MY2 FINAL MONITORING REPORT

Odell's House Mitigation Project

RE: WLS Responses to NCDEQ DMS Review Comments for Task 8 Submittal, Draft Monitoring Year 2 Report for the Odell's House Mitigation Project, DMS Full-Delivery Project ID #100041, Contract #7420, Neuse River Basin, Cataloging Unit 03020201, Johnston County, NC

1.3 Current Condition Plan View

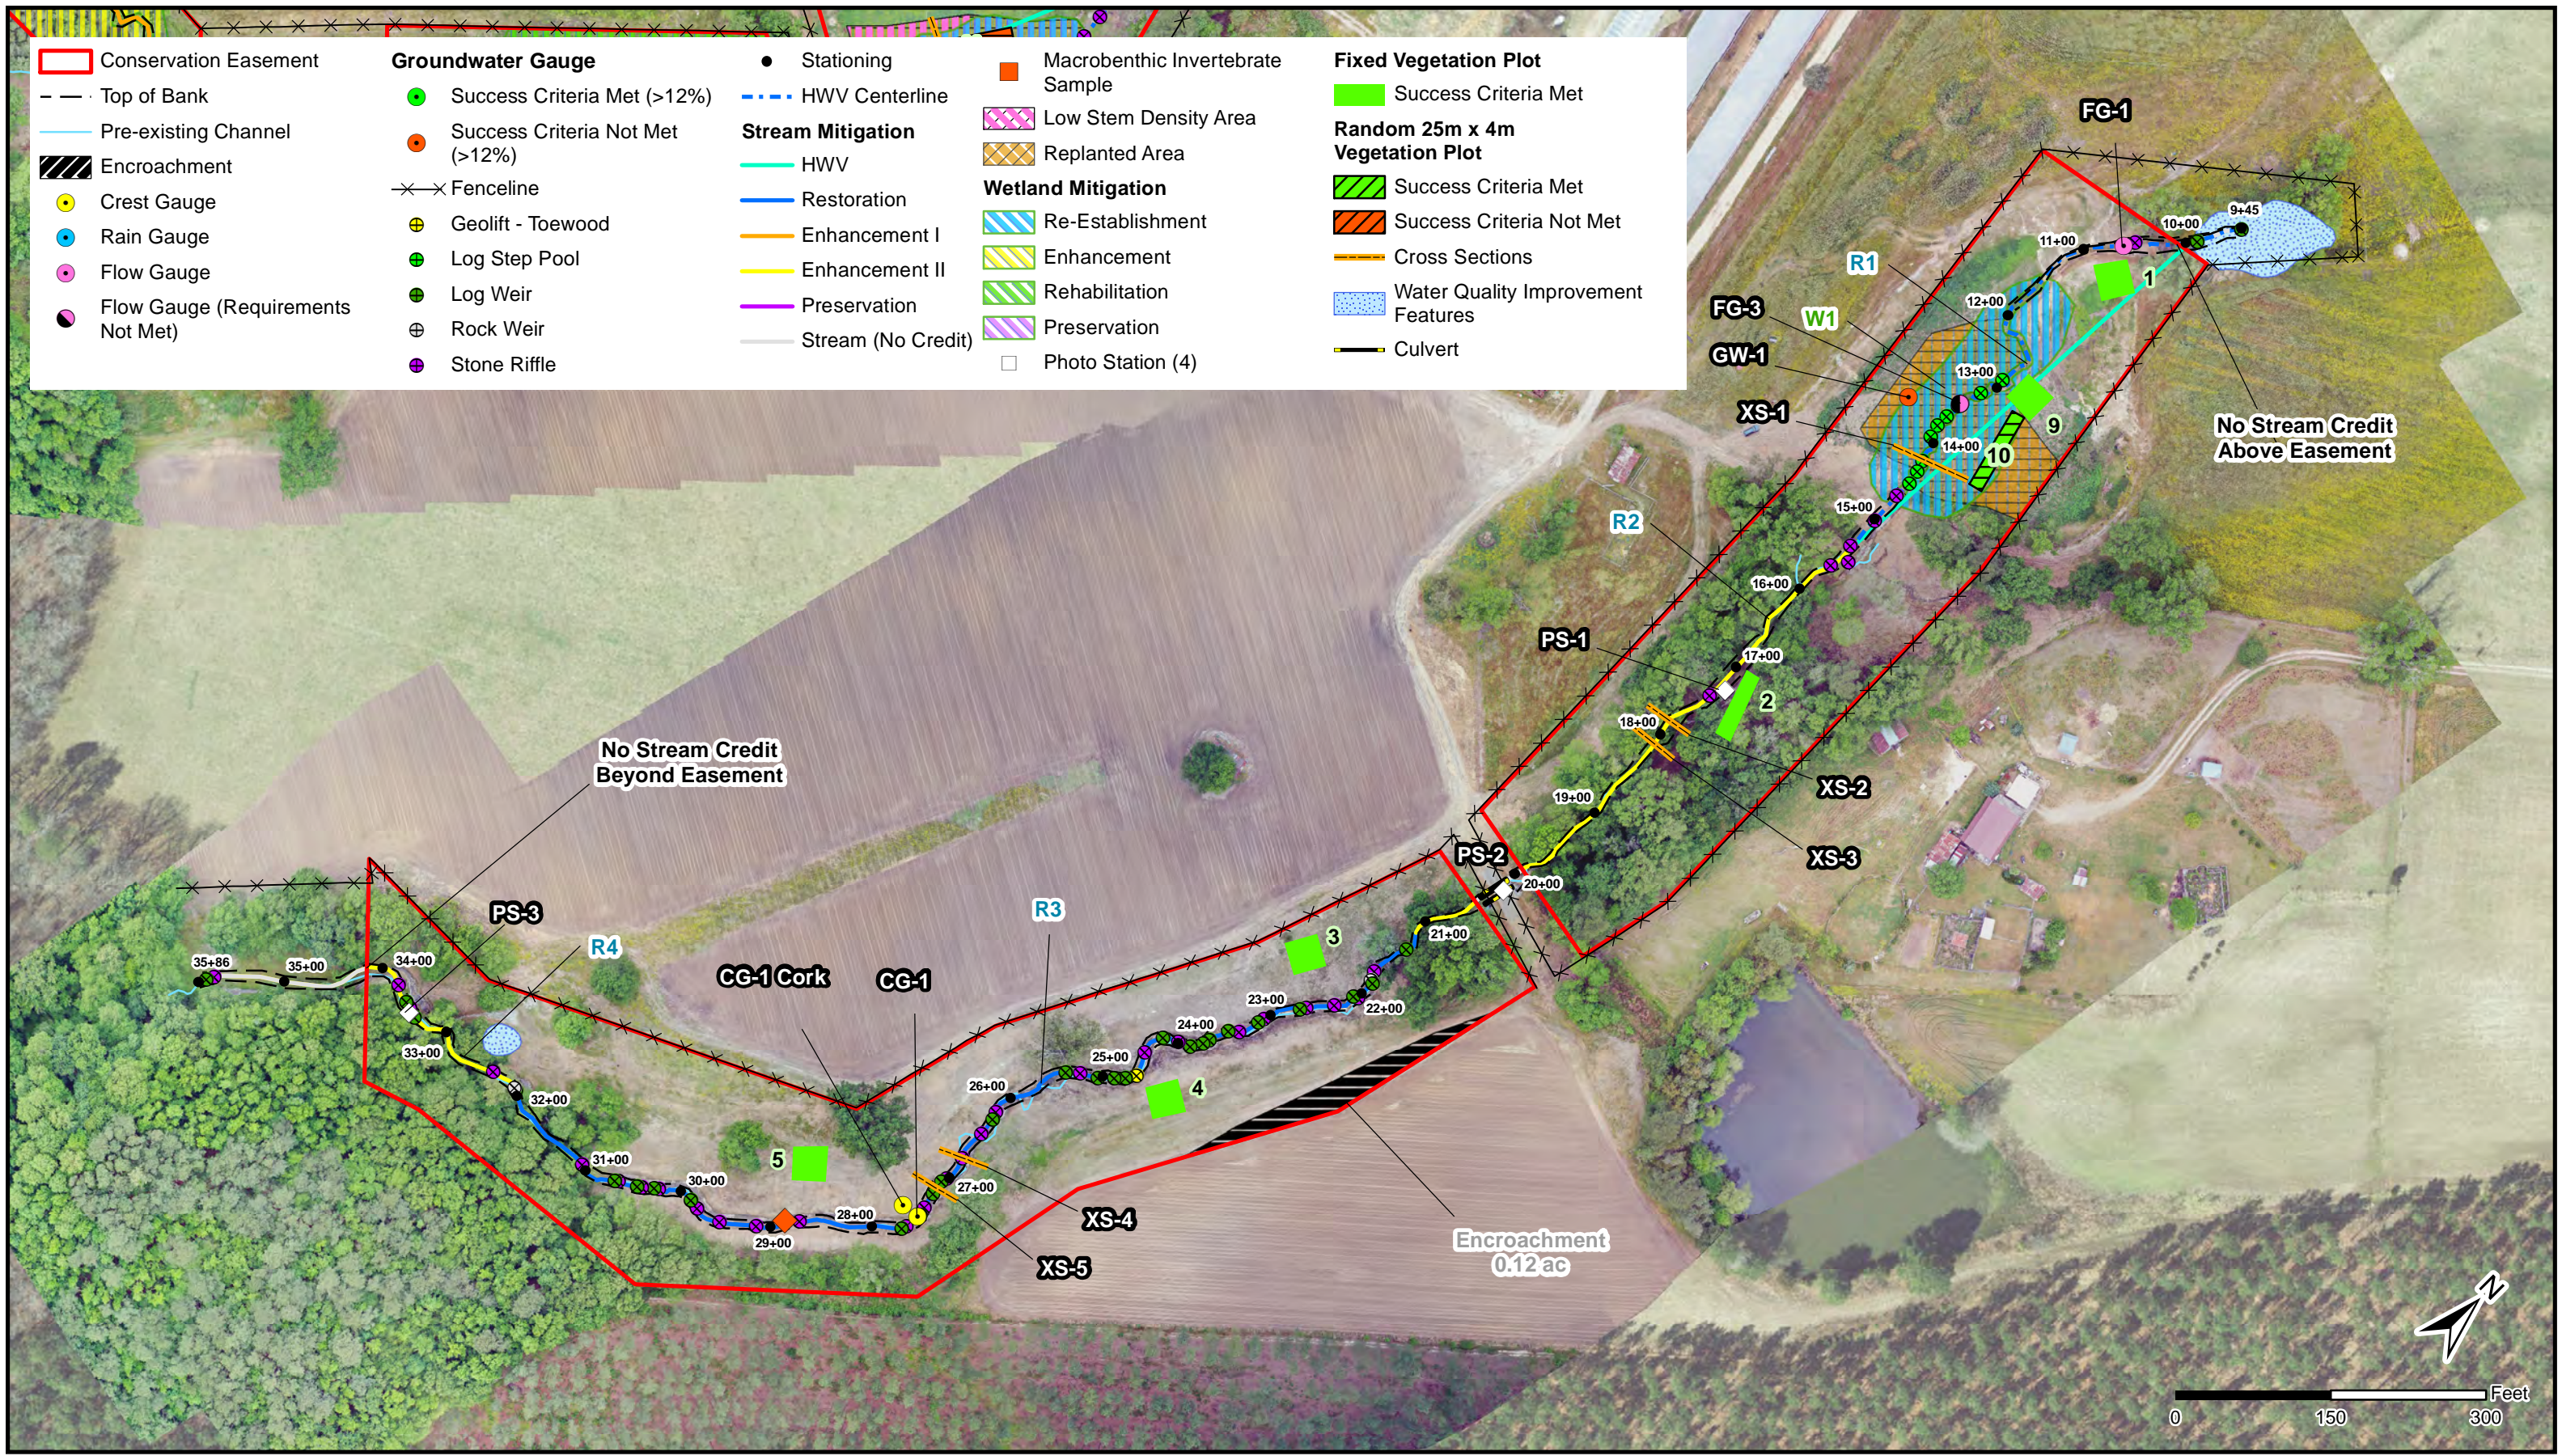
- **DMS Comment: Confirm that the 'low stem density MY2' polygon shown on the CCPV is the 1.07-acre area of replant or show replant area on CCPV.** WLS Response: The area of low stem density that was replanted was added to the CCPV. A smaller polygon (0.19 acres) within that original planted area still has a low stem density based on vegetation plot data for MY2.

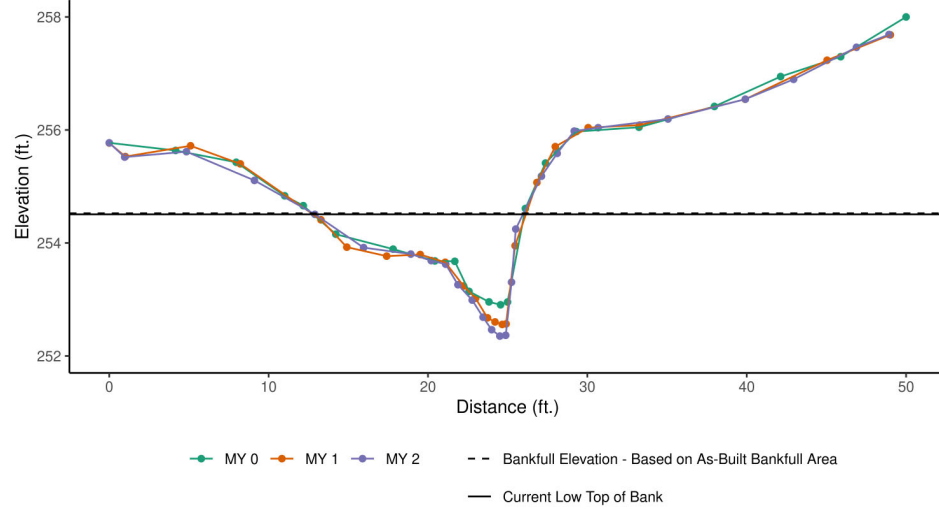
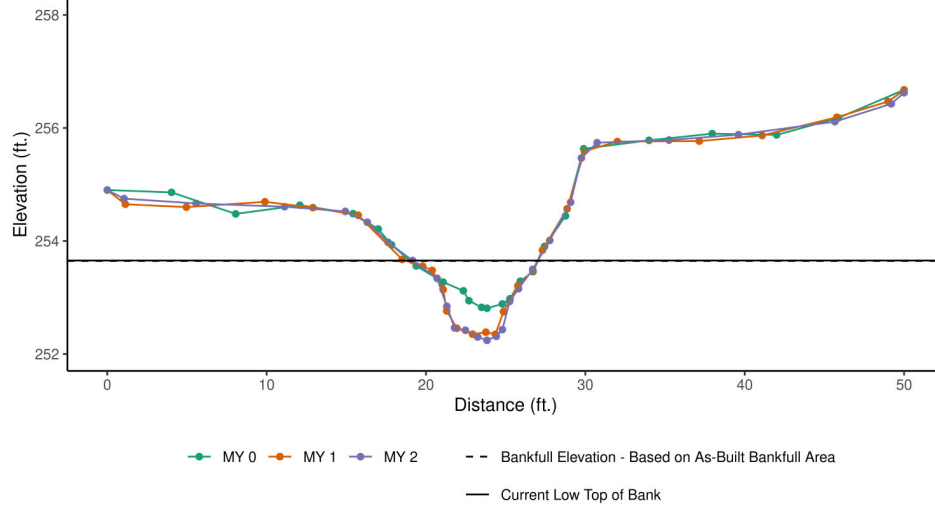
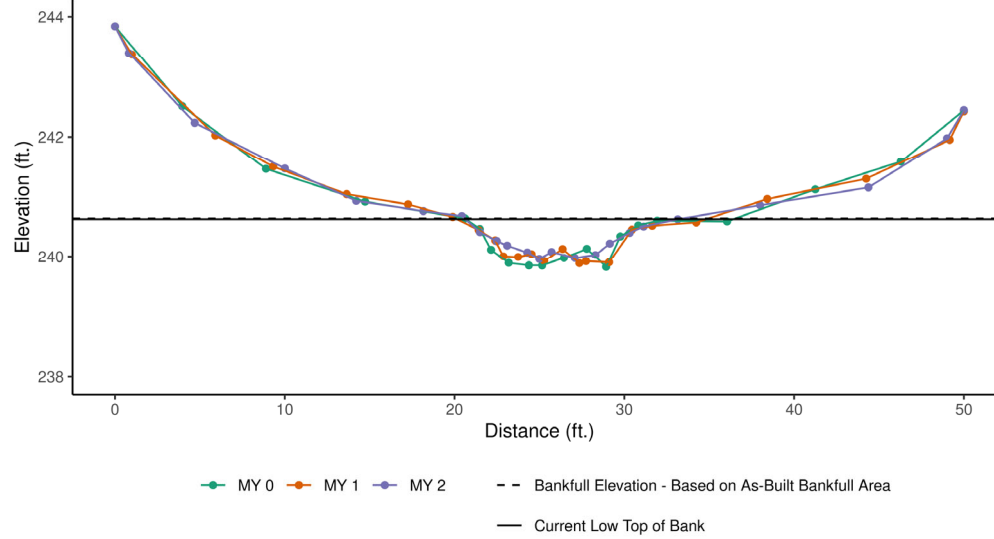
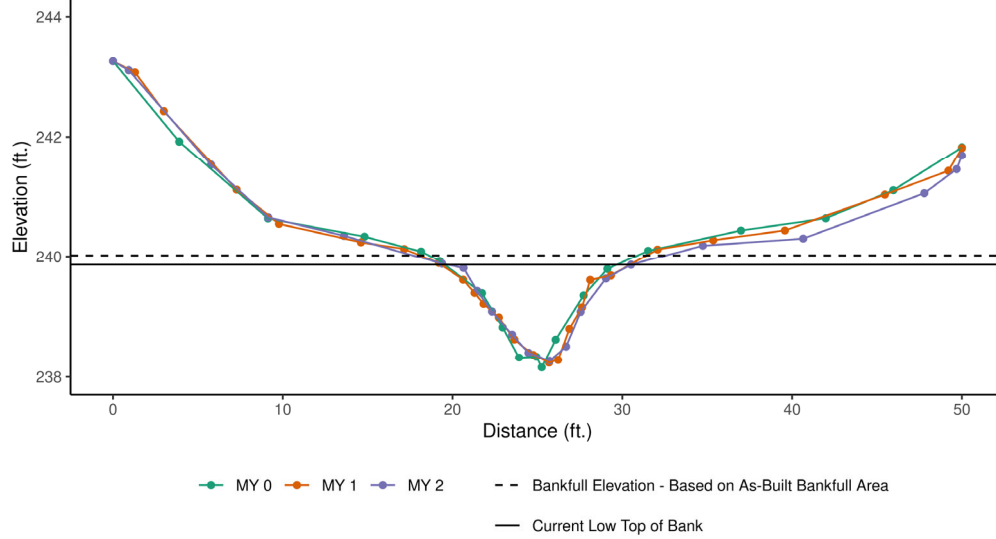
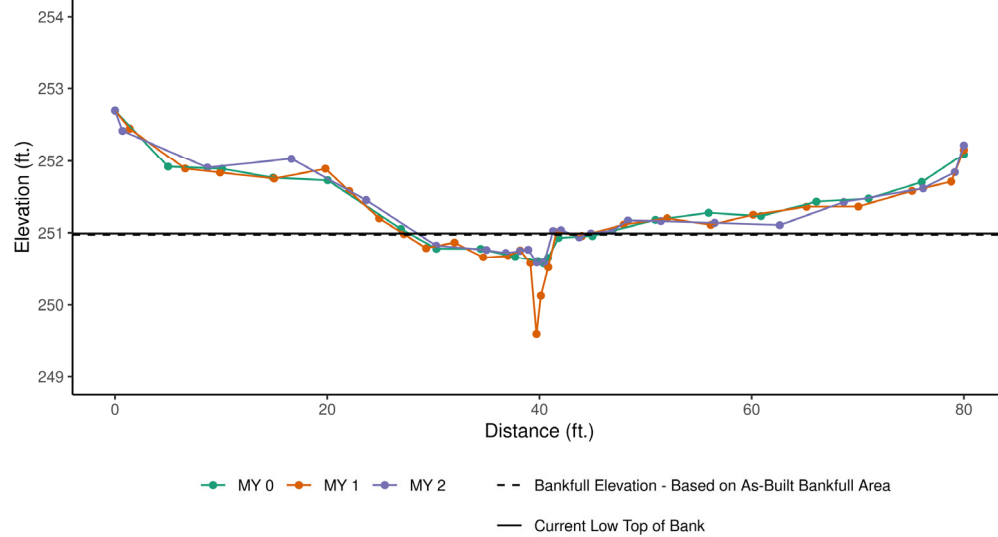
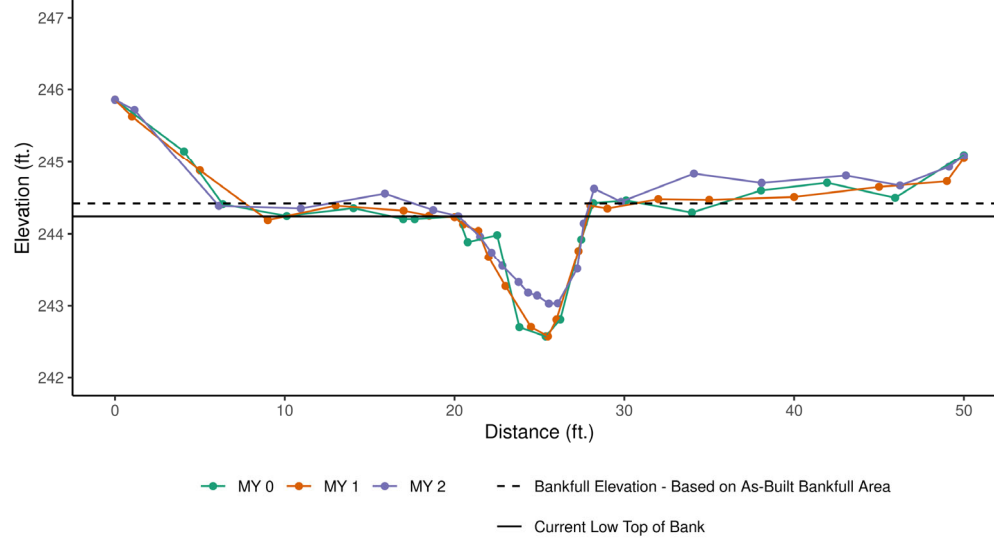
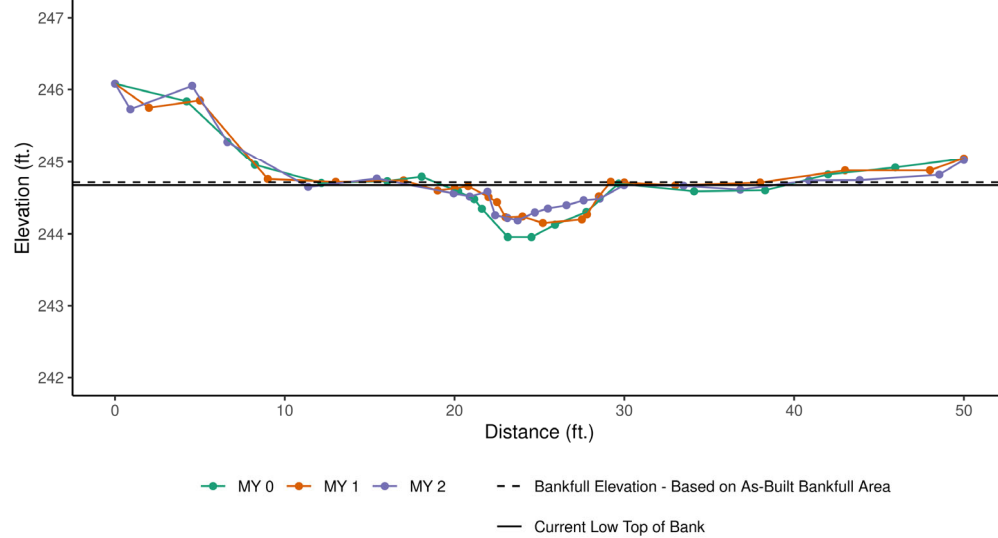
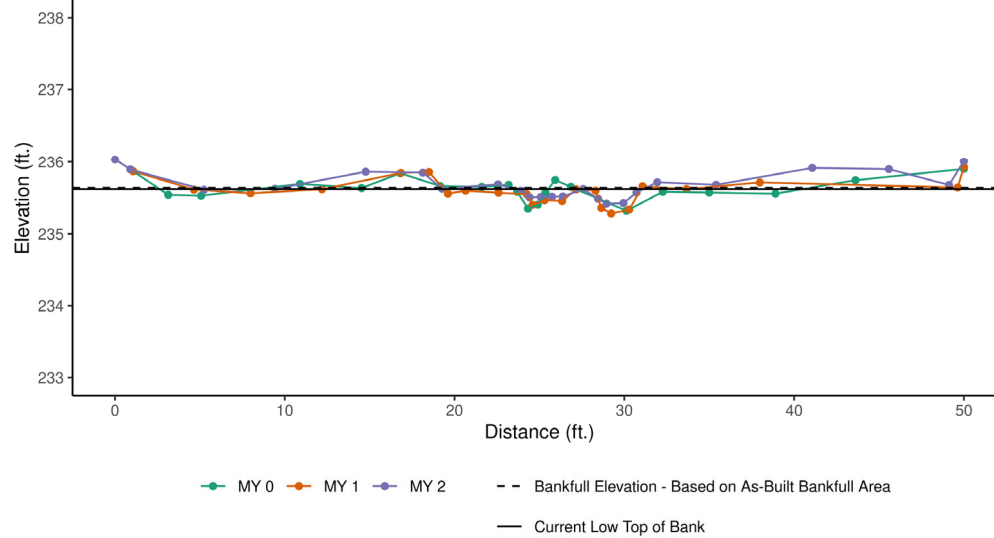
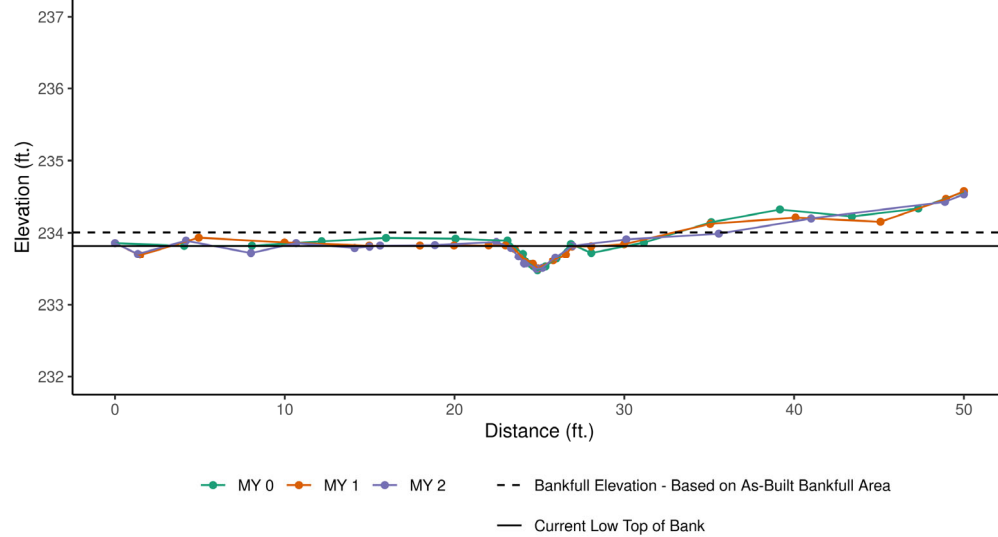
- **DMS Comment: Cross section graphs (starting at page 58 in PDF) are unclear. Confirm if this is from use of DMS tool or update with clearer visual if possible.** WLS Response: Graphics were generated using the DMS tool, but visuals became unclear when condensing into PDF. Appendices are updated with clearer visuals.
